Re: **Santa Fe ⁴ at the Trails Unit II Grading and Drainage Plan**
Engineer's Stamp dated 7-12-06 (C9/D1B)
15

Re: Tierra Vista Units 1 and 2 at the Trails, south of Woodmont and east of Pond H,
Grading and Drainage Plan (C9/D001F)

**Re: Tierra Vista Units 1 and 2 at the Trails, south of Woodmont east of Pond H,
Grading and Drainage Plan**

TOMBSTONE AVE (@ KINGMAN ST)

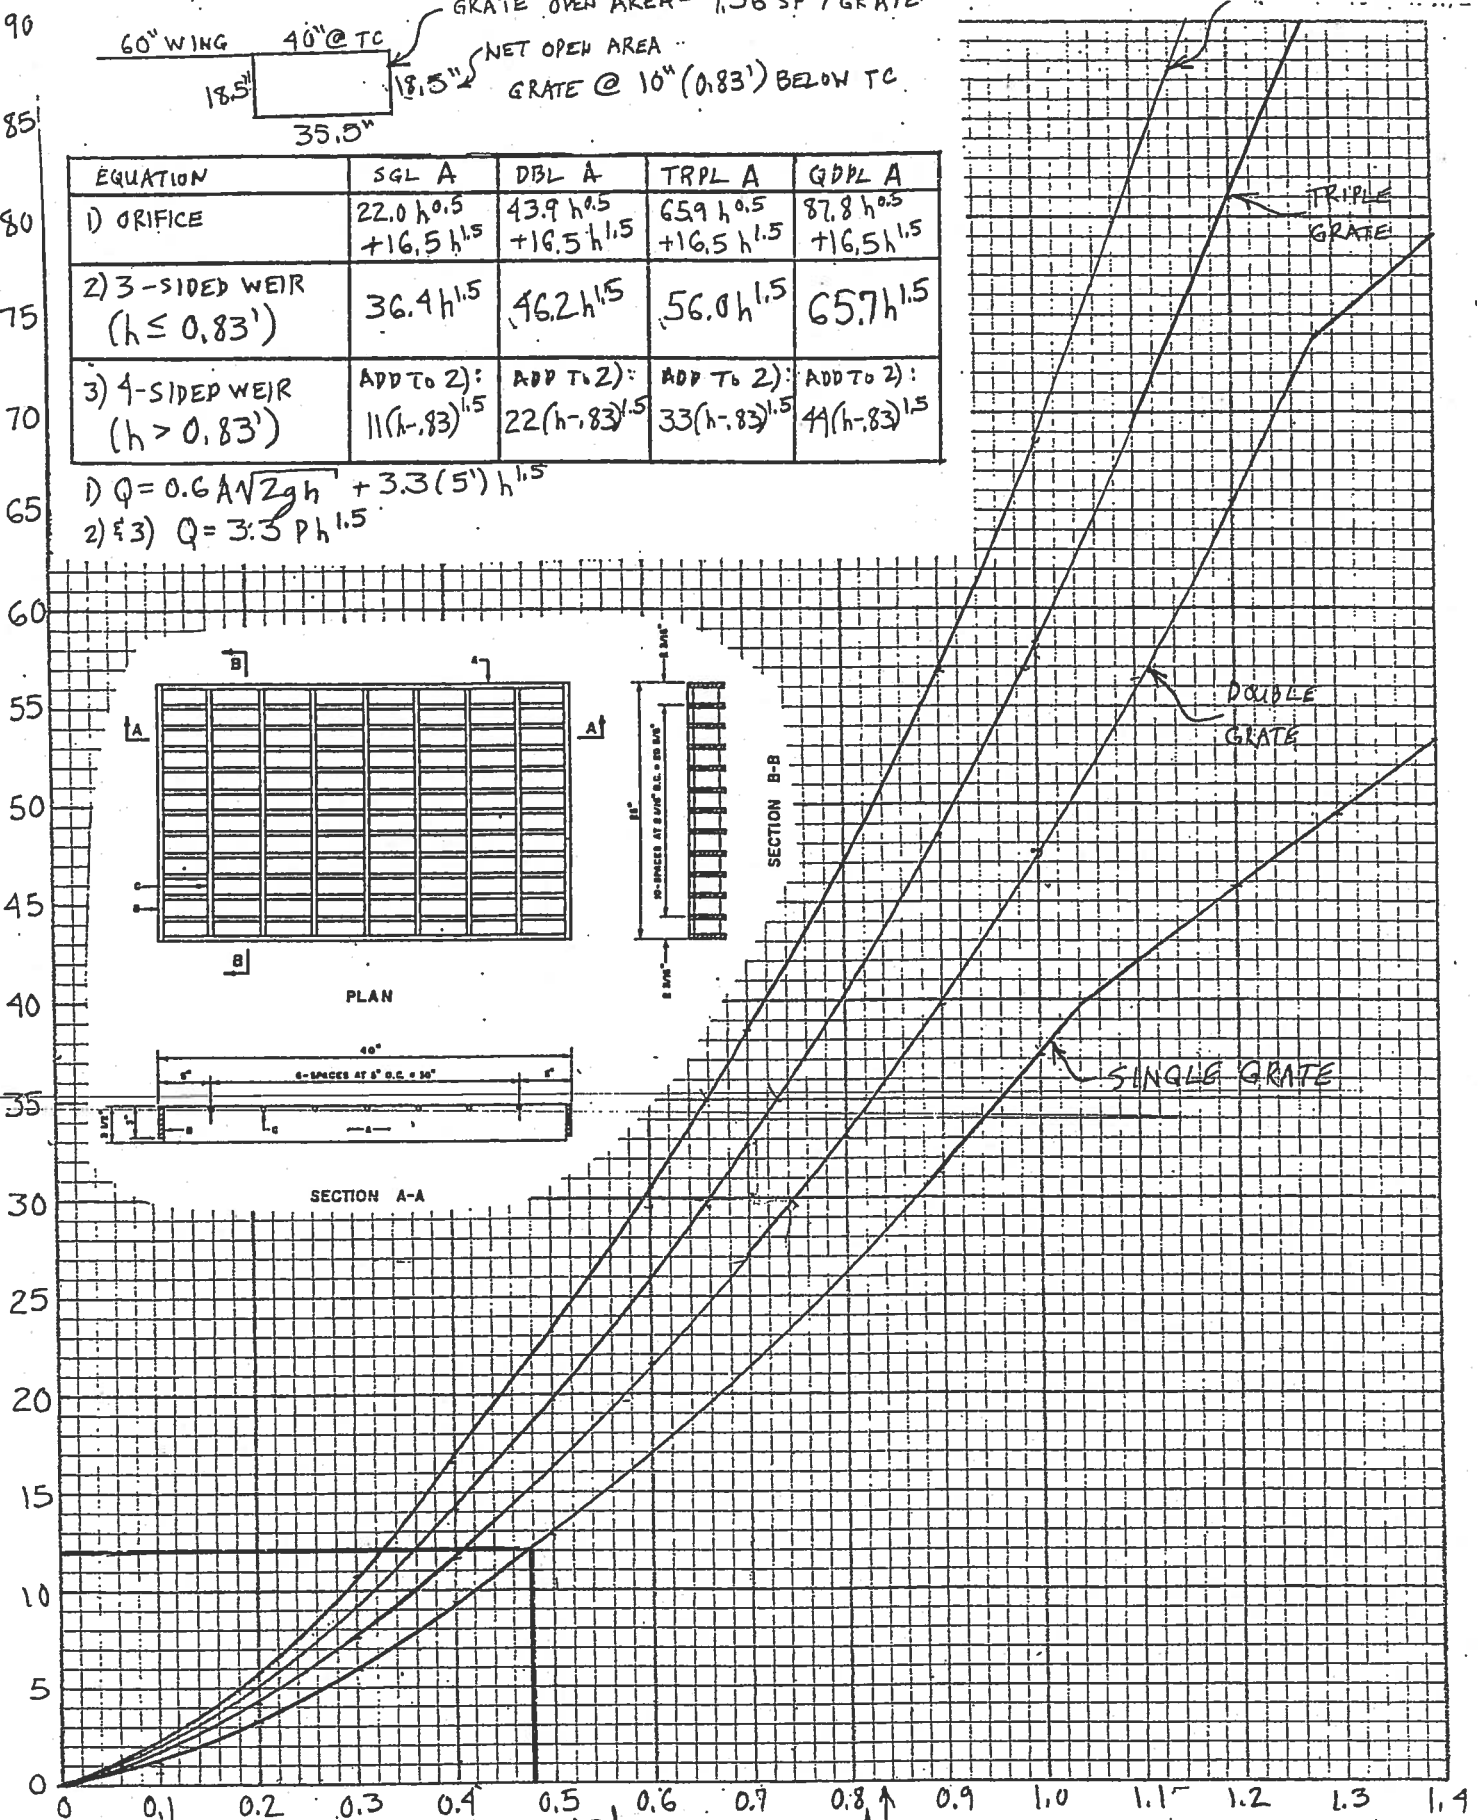
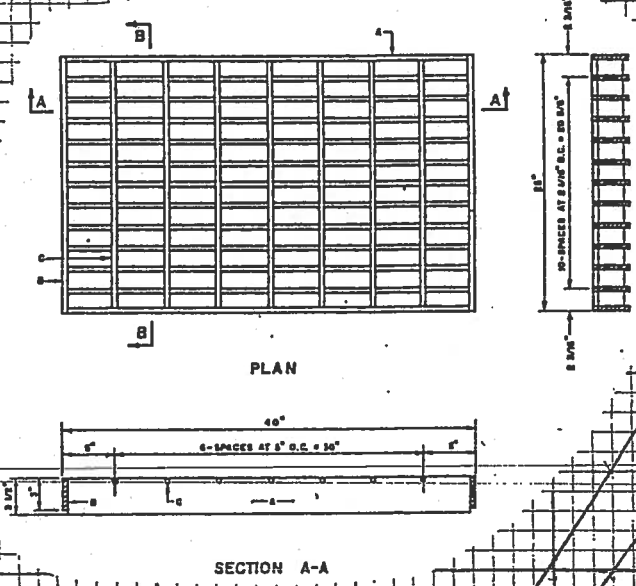
- BASIN 1 Flow = 18.7 cfs < 41.1 cfs CAPACITY ∴ OK
- Flow DEPTH @ 18.7 cfs = 0.48'
- INLET CAPACITY = 12 cfs
- 2 INLETS @ 12 cfs = 24 cfs > 18.7 cfs ∴ OK
- Flow DEPTH @ 2x 100-YR = 0.64'
 - 2 SINGLE 'A' INLETS HAVE CAPACITY TO PASS 2x 100-YR FLOW

TEMPE AVE (WEST END)

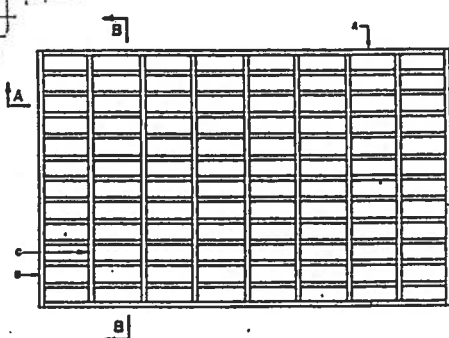
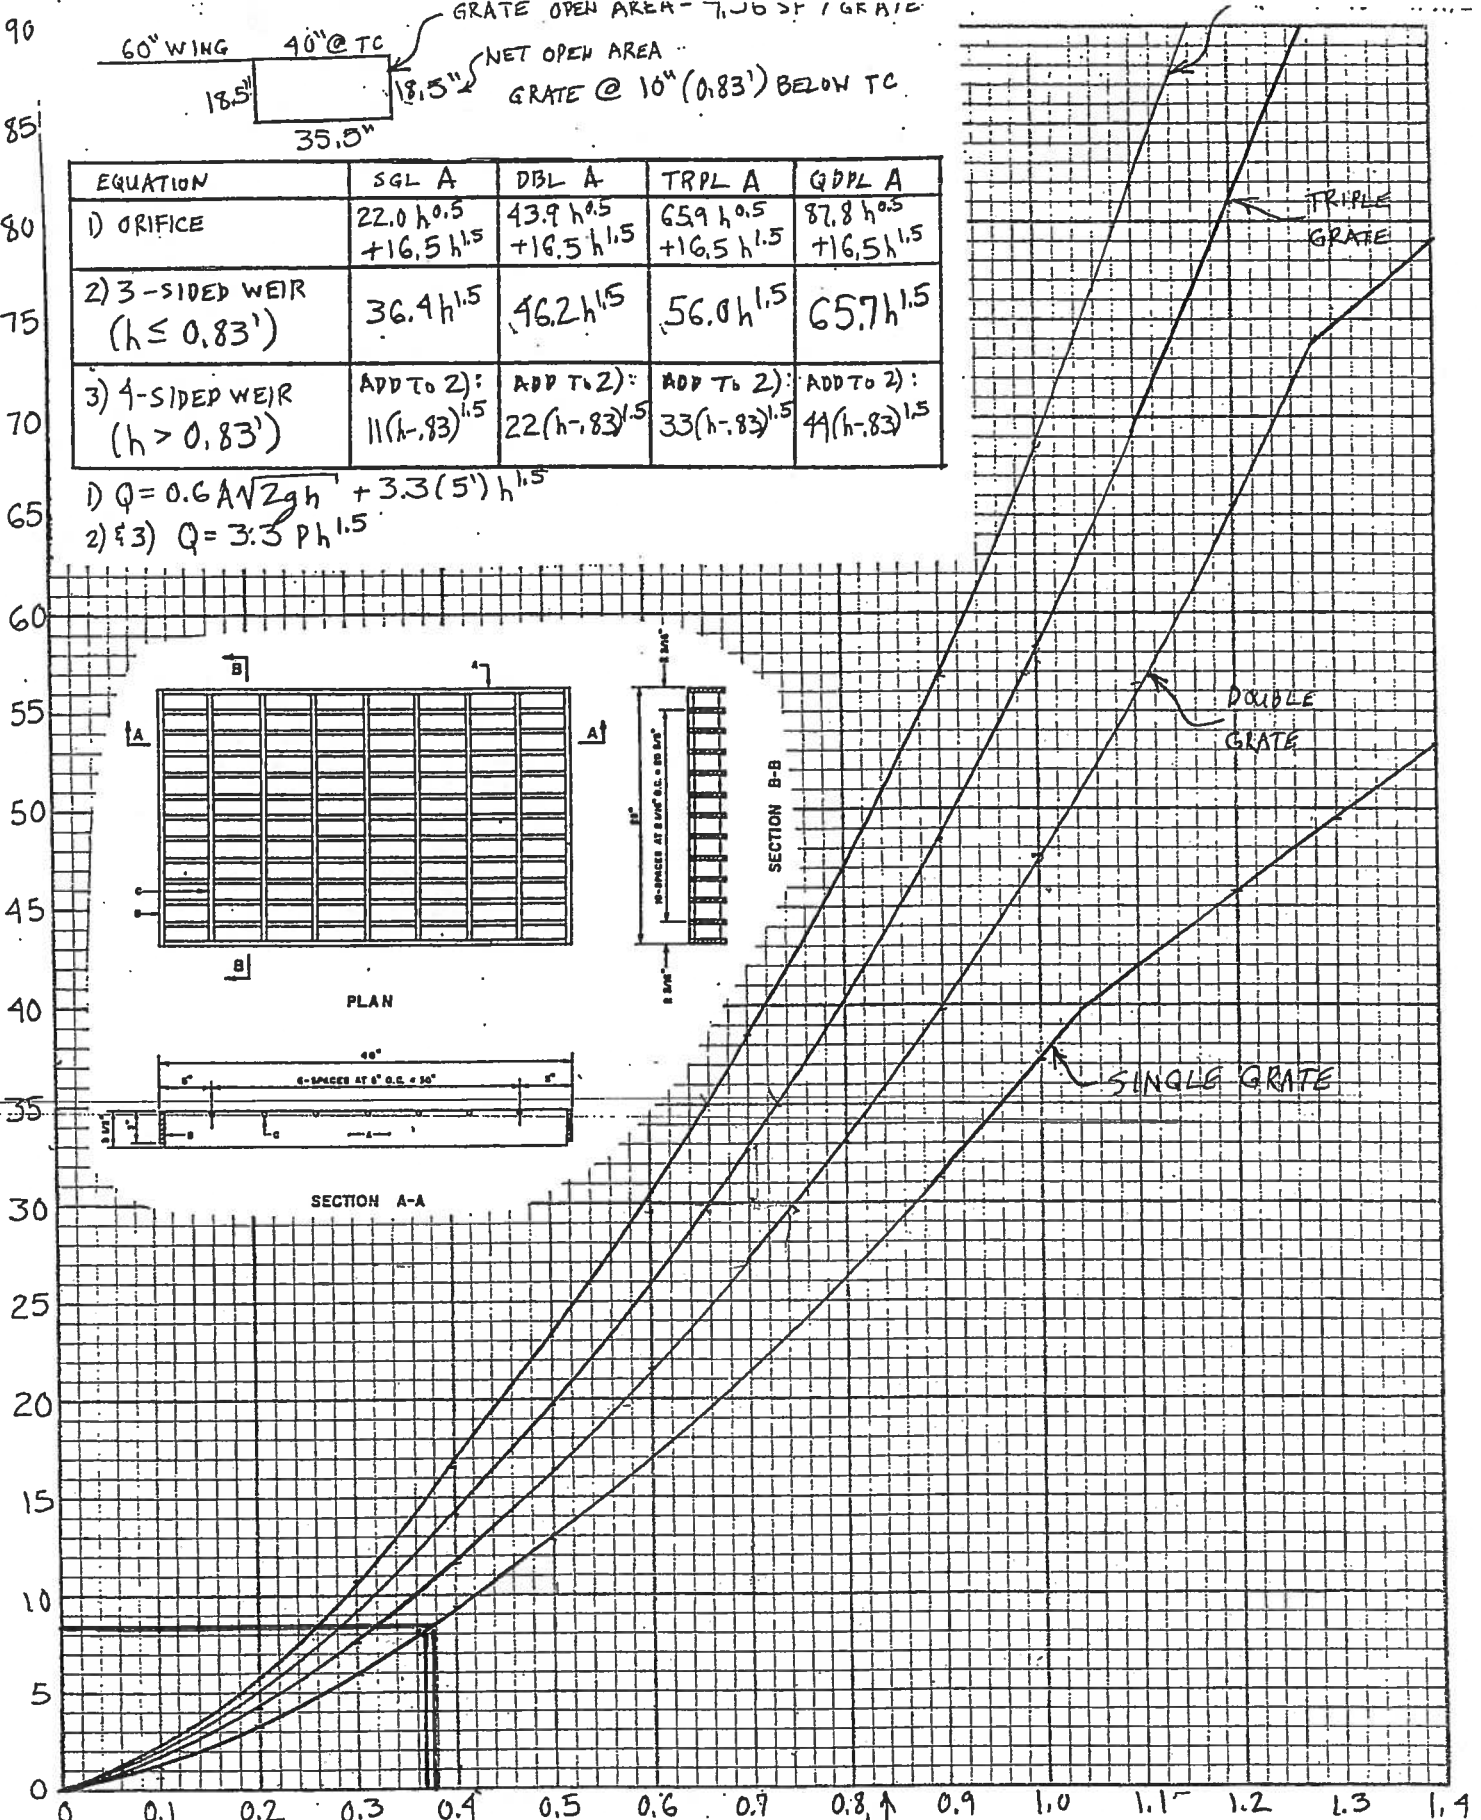
- BASIN 2 FLOW = 7.6 cfs < 41.1 cfs CAPACITY ∴ OK
- FLOW DEPTH @ 7.6 cfs = 0.38' ~~ES~~
- INLET CAPACITY = 8.4 cfs
- 2 INLETS @ 8.4 cfs = 16.8 cfs > 7.6 cfs ∴ OK
- INLETS (SINGLE A) HAVE 2x 100-YR FLOW CAPACITY

TEMPE AVE (MIDDLE INLETS EAST OF KINGMAN)

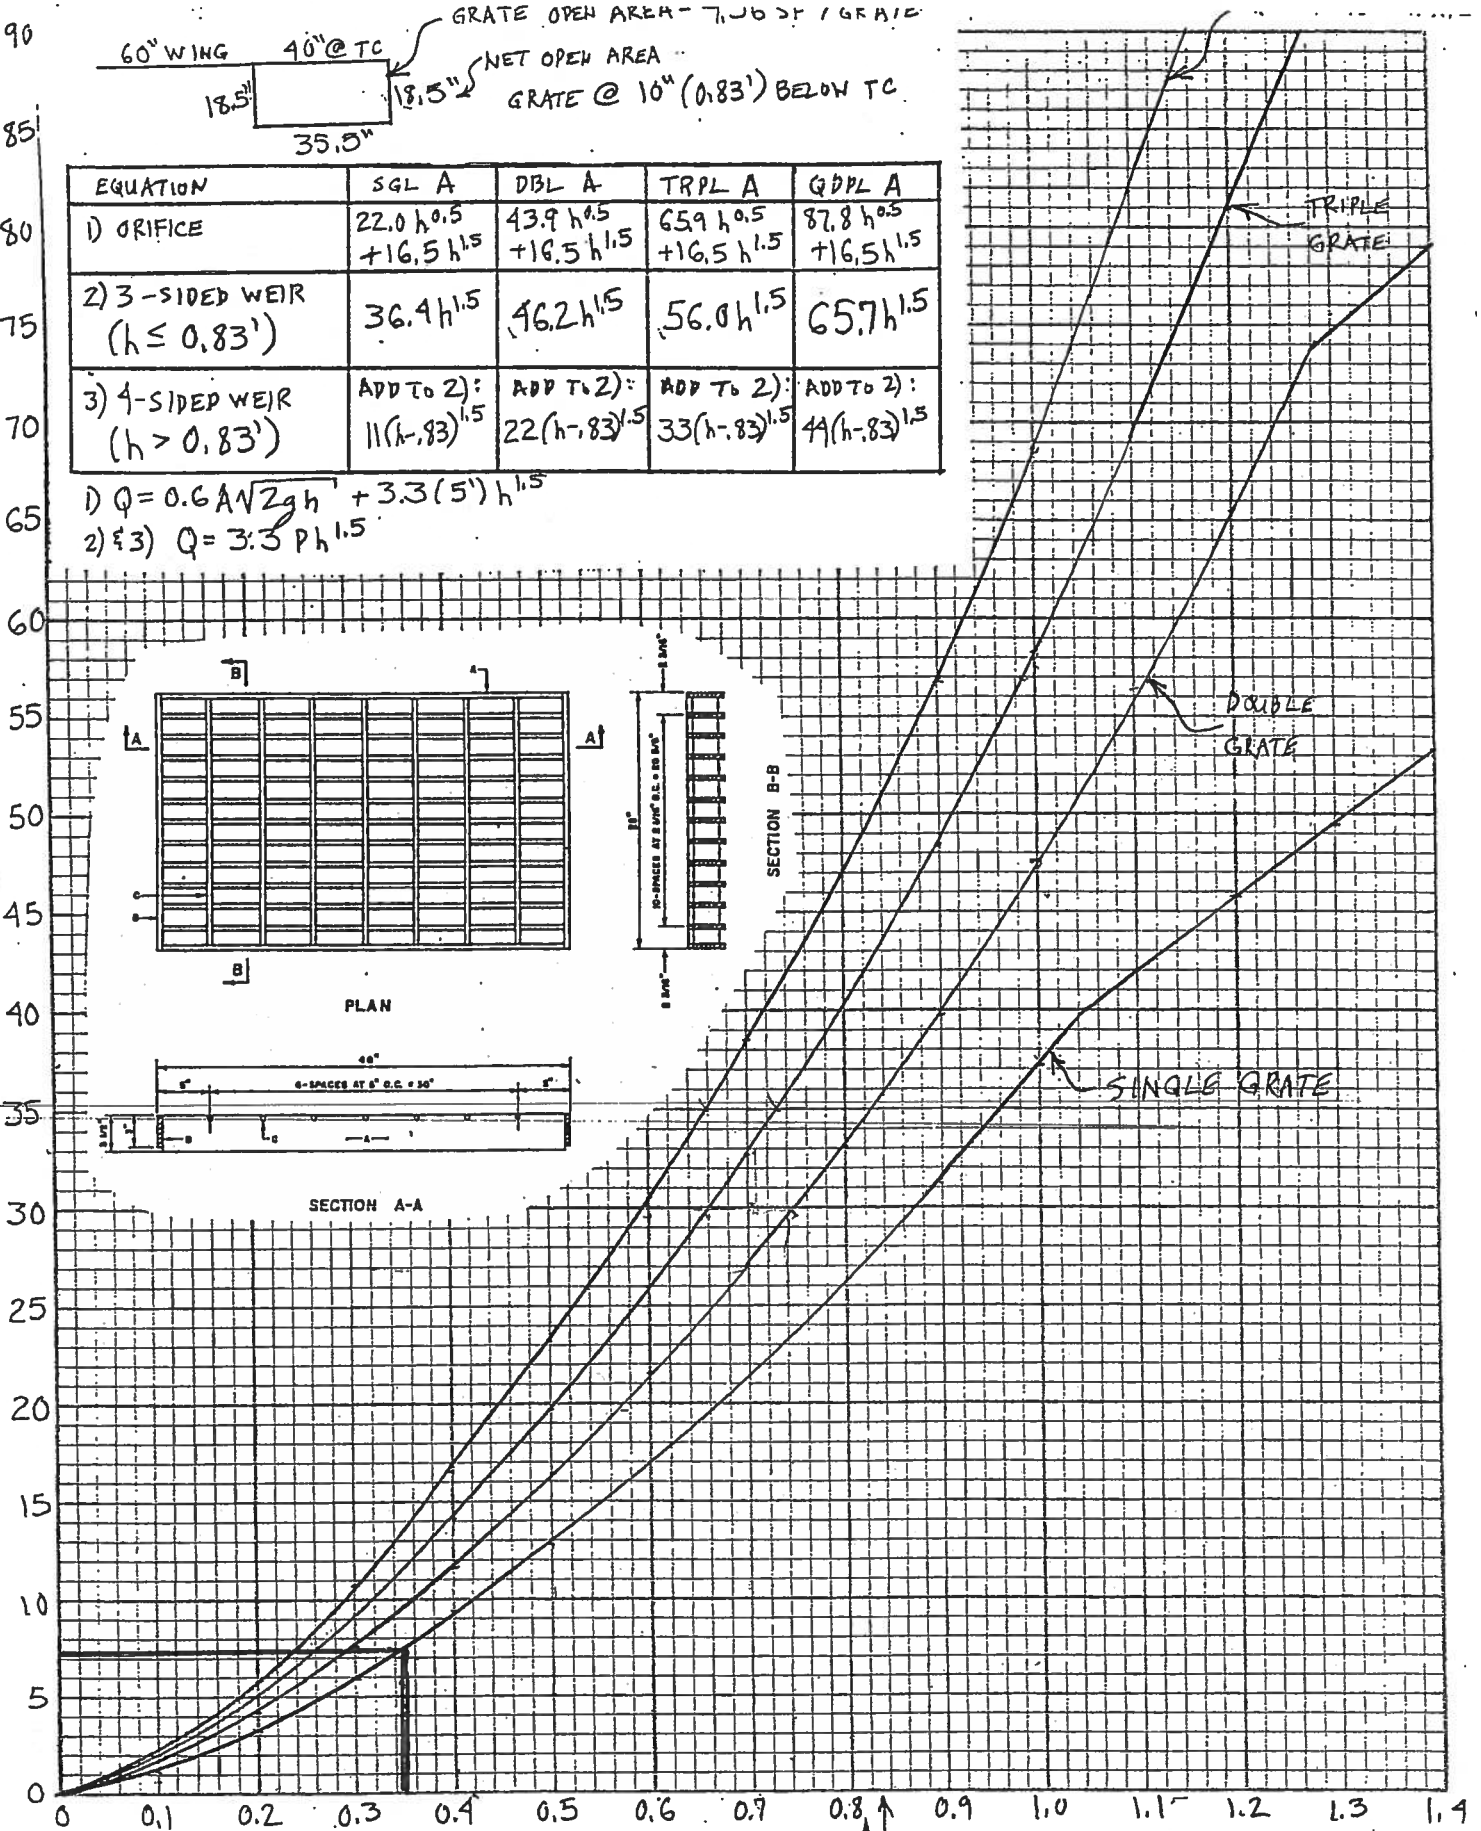
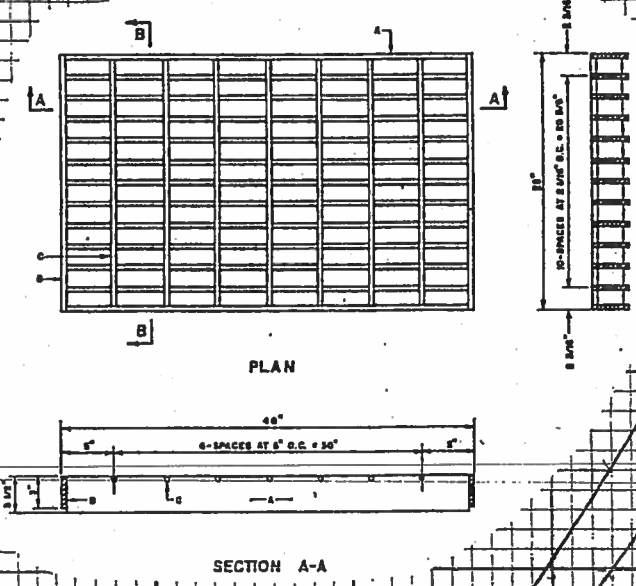
- BASIN 3 FLOW = 5.9 cfs < 41.1 cfs CAPACITY ∴ OK
- FLOW ~~DEPTH~~ @ 5.9 cfs = 0.35'
- INLET CAPACITY = 7.2 cfs
- 2 INLETS @ 7.2 cfs = 14.4 cfs > 5.9 cfs ∴ OK
- INLETS (SINGLE A) HAVE 2x 100-YR FLOW CAPACITY

TEMPE AVE (EAST END)

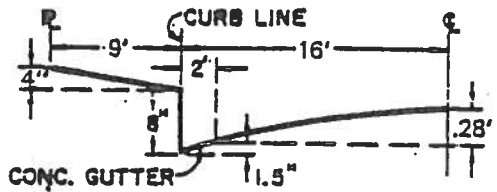
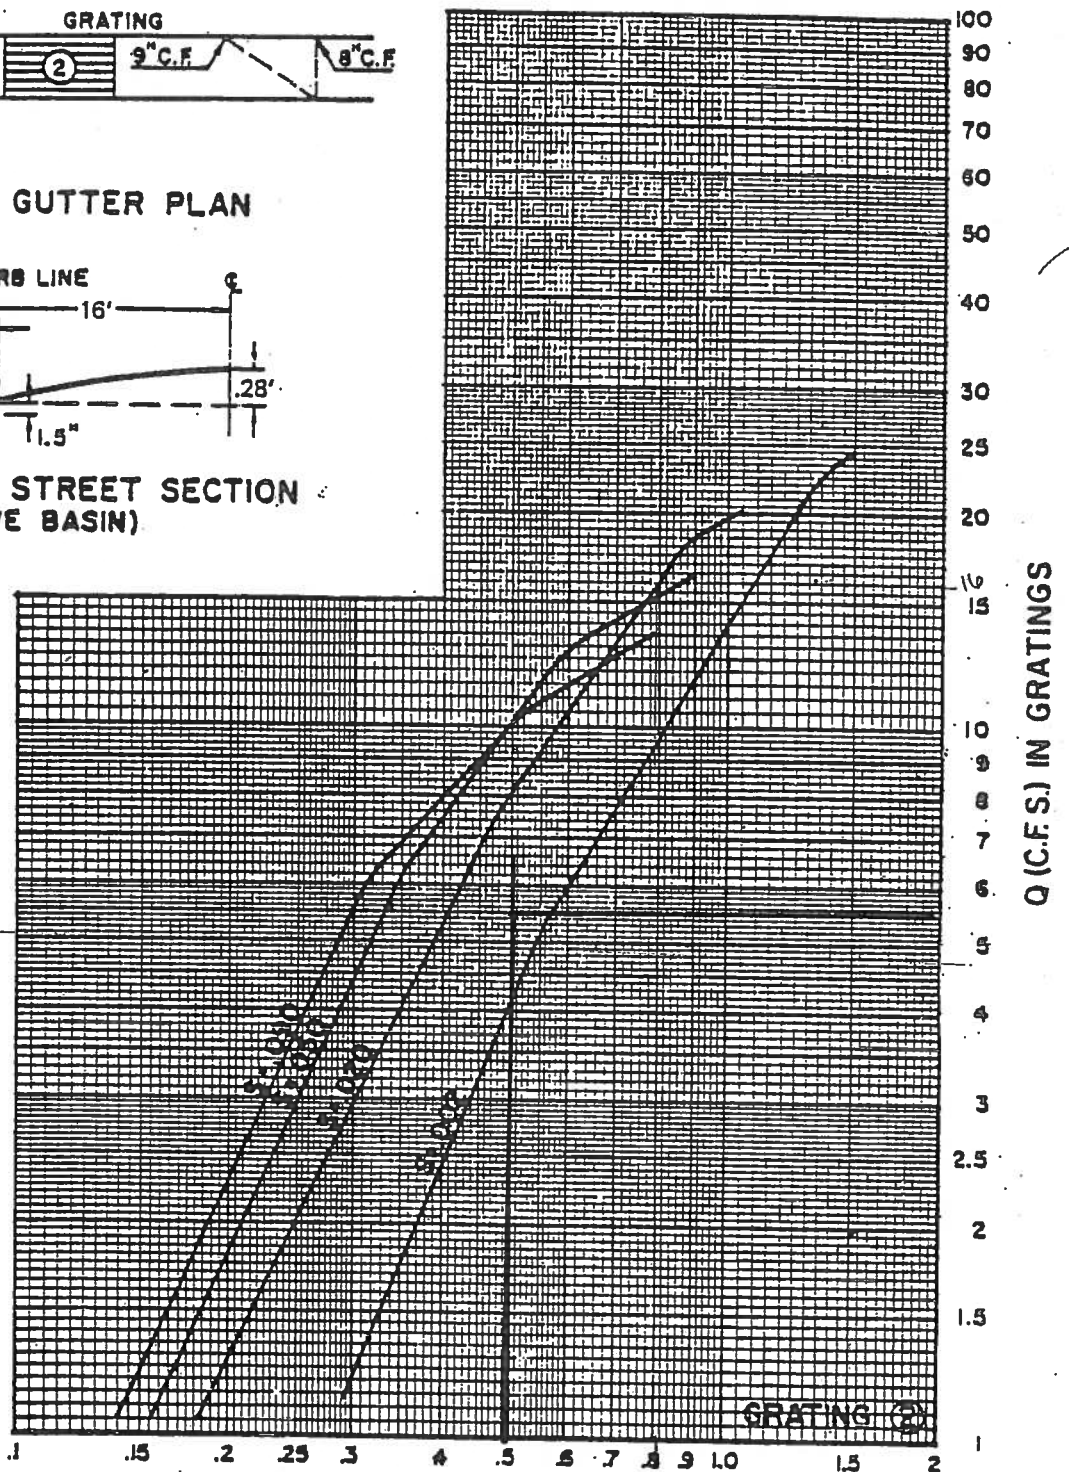
- BASIN 4 Flow = 22.4 cfs < 41.1 cfs CAPACITY ∴ OK
- Flow DEPTH @ 22.4 cfs = 0.51'
- INLET CAPACITY = 5.5 cfs (SEE NOMOGRAPH)
- 2 INLETS @ 5.5 cfs = 11 cfs
- By-Pass Flow = 11.4 cfs - High

- D = 0.51'
- Q = 5.5 cfs
